TOWN OF LYONS, COLORADO
RESOLUTION 2020-91

**A RESOLUTION OF THE TOWN OF LYONS COLORADO TO APPROVE THE SEVENTH
AMENDMENT TO THE CONSTRUCTION AGREEMENT WITH WALSH CONSTRUCTION INC.
FOR BOHN PARK PHASE II - PROJECT: PW20E-2**

Walsh Construction, Inc.
Change Order Proposals

PROJECT: Town of Lyons - Bohn Park (Phase 2)

3 Typ. Gate Post
01 Qty. (2) As Detailed
Qty. (2) Mirrored

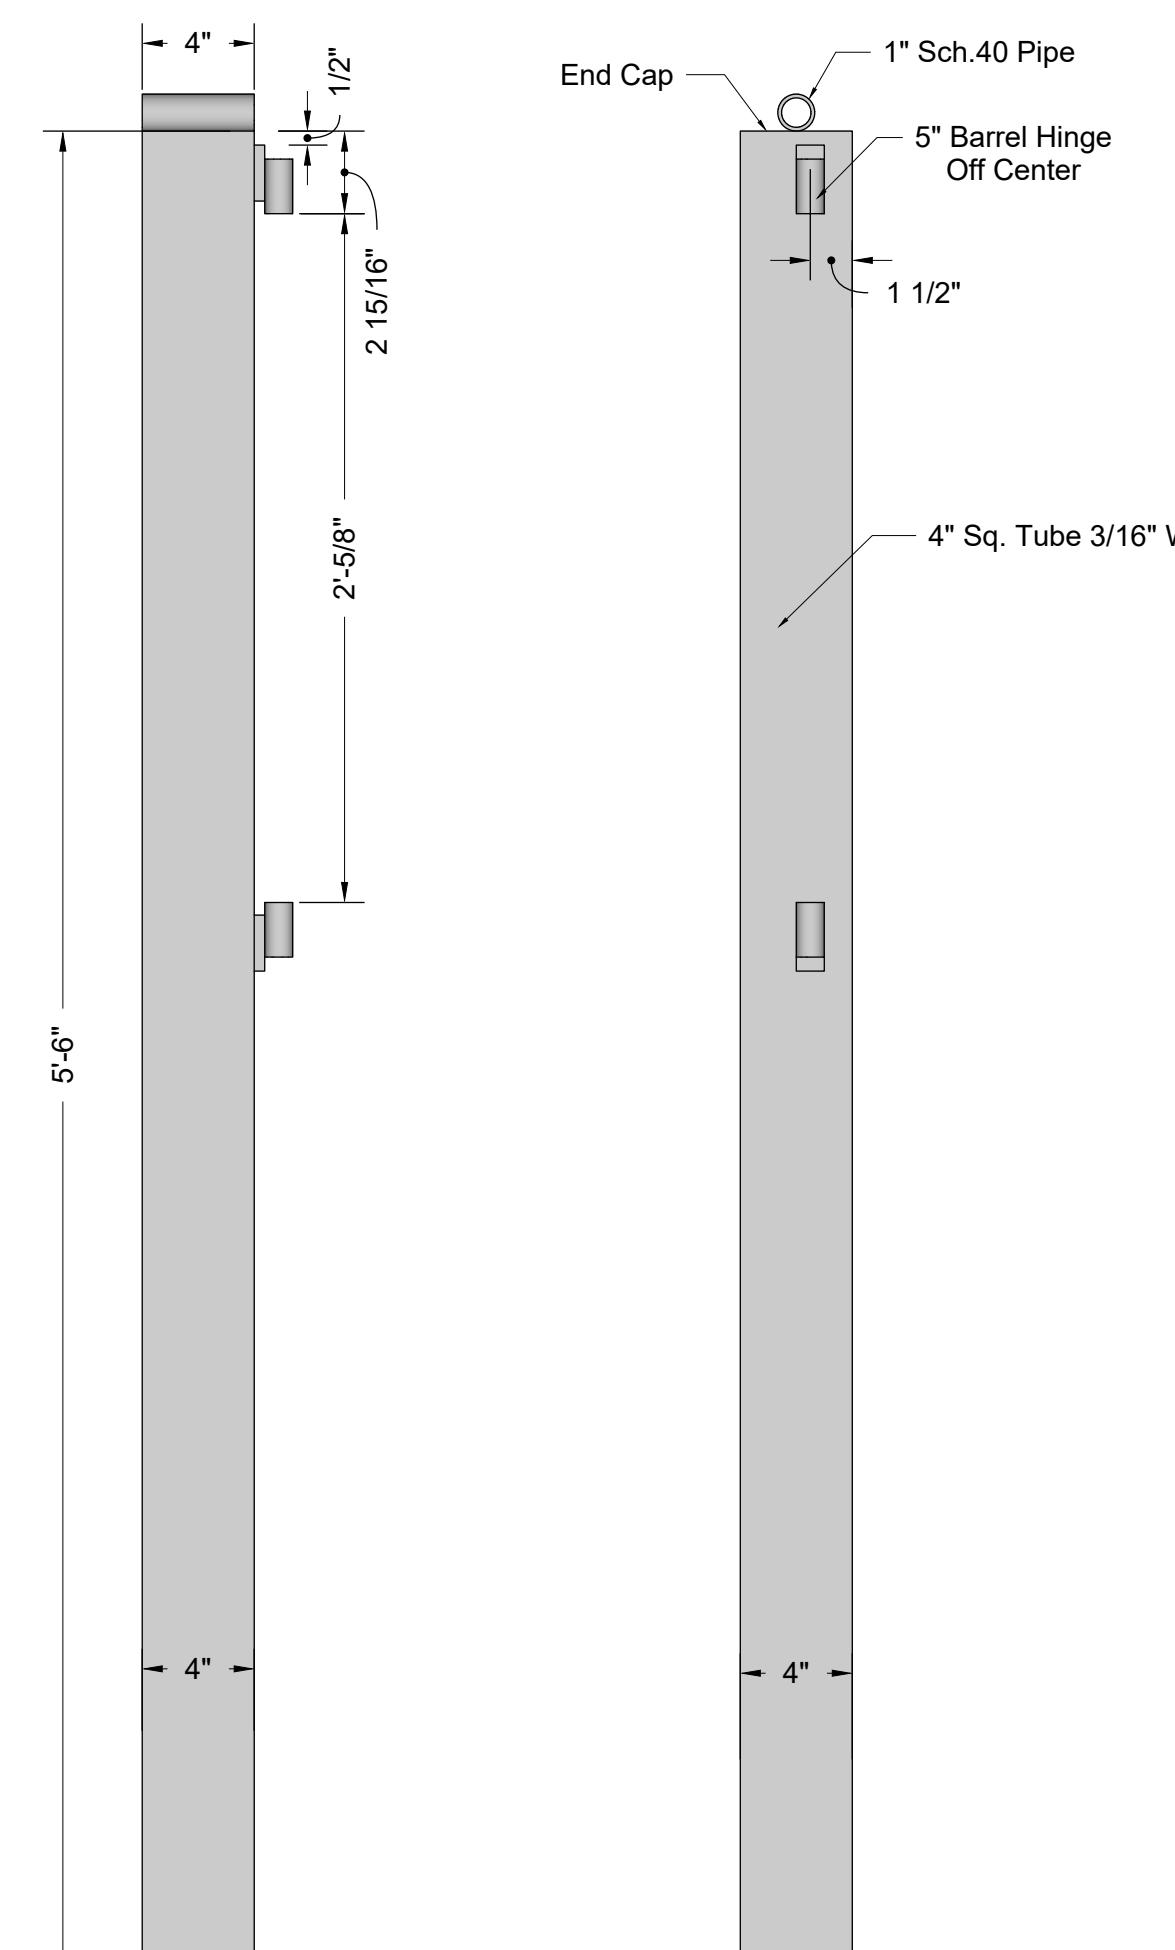
At the request of the Town, 2 sets of additional Trail Gates were added at the north entrance to Bohn Park in order to limit vehicular access to the park from the north entrance, while maintaining 2nd Street access for pedestrians using the adjacent sidewalk and crusher fines paved trail. To help offset cost for this revision, the Town received a cost credit for material that was deleted from the original plan design, which included a 10' length Heavy Duty Tube Gate and 4x4 posts that were not installed at either location. The cost for materials was found to be fair and reasonable when compared with average material cost data found on websites with similar dimensional and material properties. Labor rates met the minimum requirements of 2020 Davis Bacon standard wage rates for Boulder County, Colorado and industry standard rates for specialized drafting. This amount will be paid as a Contract Amendment. See attached documents and related plan sheets for breakdown of costs.

NOTES: Please find attached the following from Distinctive Welding - shop drawings for the Trail Gates per the revised detail on Sheet L2.5 from DHM Design. Please note that the reflective tape shown on DHM's drawings will be applied by Walsh Construction after installation. Thanks!

Finish: ~~Powder Coat Color TBD~~ Black

Revised Final Plan Sheet IR1.5

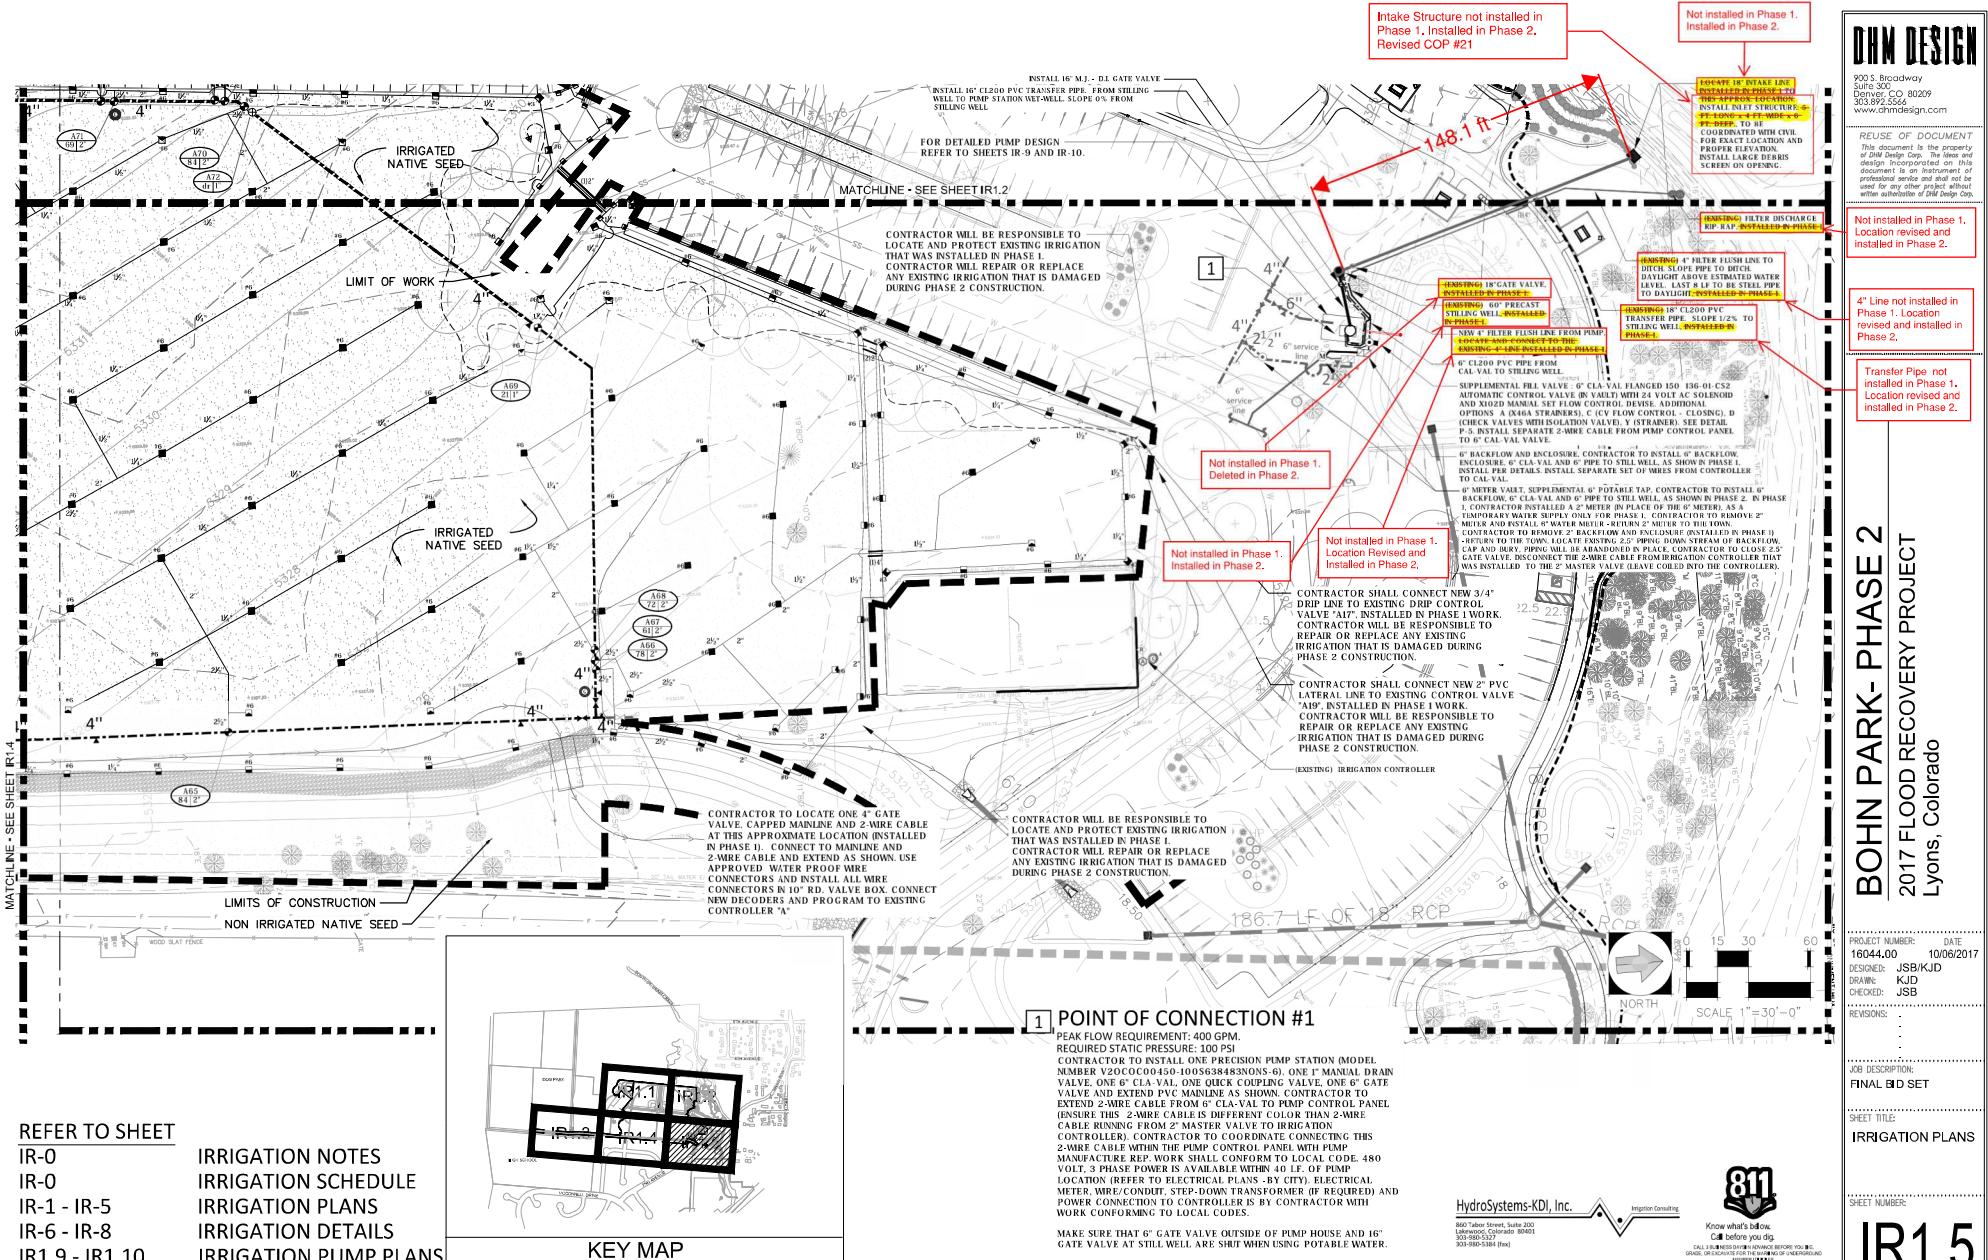
The original plan design for the Irrigation Pumping System showed installation of a 5' ID Precast Stilling Well and approx. 148Lf of 18" Class 200 PVC Intake Piping to be installed during Phase 1 construction. Due to amendments to the contract by the Town of Lyons and changes in the contract schedule, work on this item was revised to completion during Phase 2 construction. This change required the contractor to purchase and install the 5' ID Precast Stilling Well and 18" Intake Piping during Phase 2 construction and the cost for these items was not included in the original bid schedule or as part of the original scope of work. The cost for materials and labor was found to be fair and reasonable when compared with cost data found on websites with similar dimensional and material properties, 2019 Davis Bacon minimum wage rates for Boulder County, CO. and resulted in a total overall cost savings of \$1,186.83. (see attachment #2 for cost comparisons). The cost total for this revision will be paid as a Contract Amendment #6. See attached documents for overall break out of costs.

QUANTITY	SPEC. SECTION	DESCRIPTION
1	IR1.9/IR1.10	PRECAST SHOPS FOR STILLING WELL- REV4

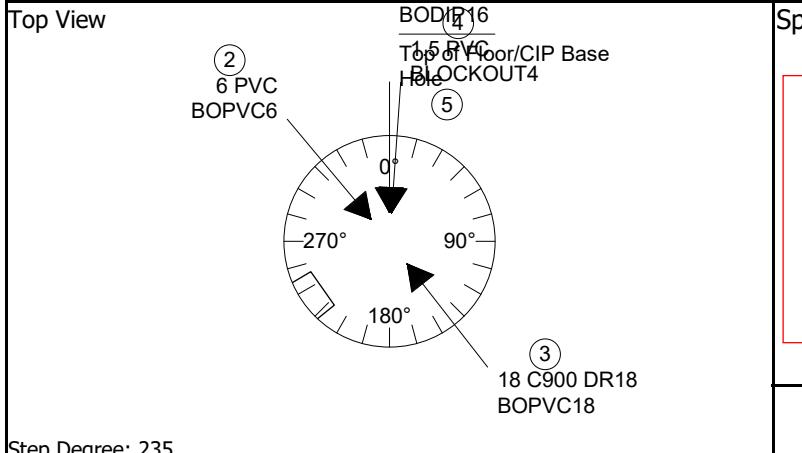
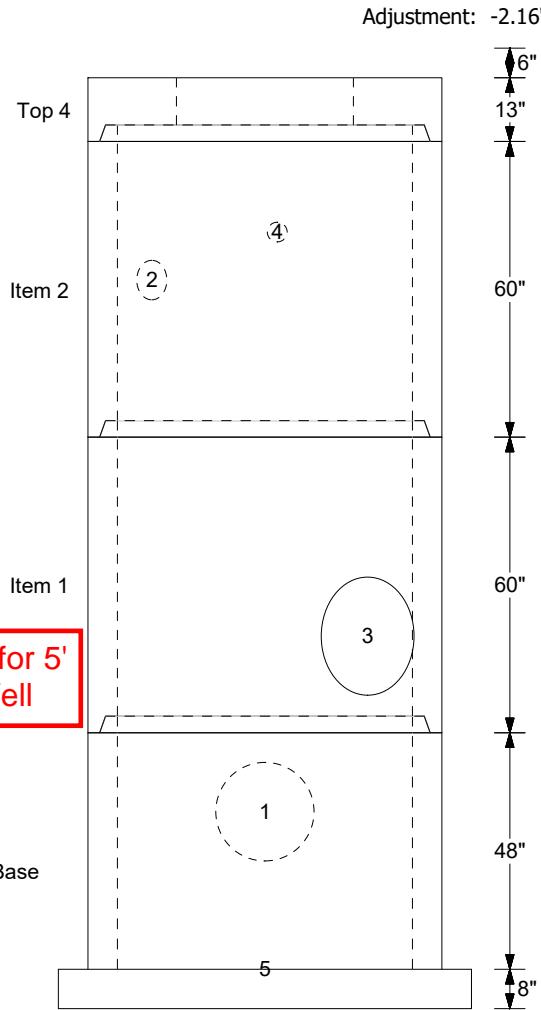
NOTES: Please find attached revised precast shop drawings for the Stilling Well. Revisions made were the following - intake piping invert lowered 9" to 5313.92' (invert at Intake Structure is 5314.67'), pipe entrances for the 6" potable refill (raised to 4' below Finish grade) and 1-1/2" poly line (raised to 3' below finish grade). Rim elevation remained. Thank you.
